| Title | Corrections for the definition of repetition code |
| Re: | IEEE P802.16e/D3-2004 |
| Abstract | Proposing corrections for the definition of the repetition code in 802.16REVd |

[Change Figure 252 to include the following single diagram]

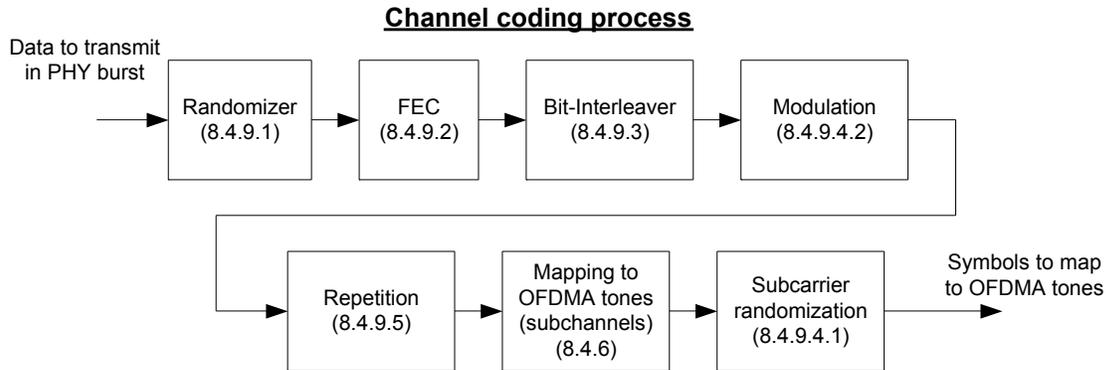
Channel coding procedures include randomization (see 8.4.9.1), FEC encoding (see 8.4.9.2), bit interleaving (see 8.4.9.3), ~~and~~ modulation (see 8.4.9.4), **and repetition (see 8.4.9.5).**

[Erase the remainder of the paragraph, from “When repetition code is used, “ to “shown in Figure 252.”]

8.4.9.5 Repetition

Repetition of $r = 2, 4,$ or 6 shall be applied to the modulated symbols before mapping to subchannels. The number of allocated slots (N_s) shall be a whole multiple of the repetition factor r . The FEC, interleaving and modulation shall be applied to N_s/r slots. Then, each slot will be repeated r times to form r contiguous slots. The repetition scheme includes a rotation of the modulated symbols in order to ensure that repeated modulated symbols are not be mapped to adjacent tones.

Let $R_{in}[s, k]$ be the repetition block input for slot s ($s = 0 \dots N_s/r - 1$) and tone k ($k = 0 \dots 47$), and $R_{out}[s, k]$ the repetition block output for slot s ($s = 0 \dots N_s - 1$) and tone k ($k = 0 \dots 47$), then the repetition is defined by equation XX:

$$R_{out}[s, k] = R_{in}[\text{floor}(s/r), (k + 7 \cdot (s \bmod r)) \bmod 48] \quad (\text{XX})$$
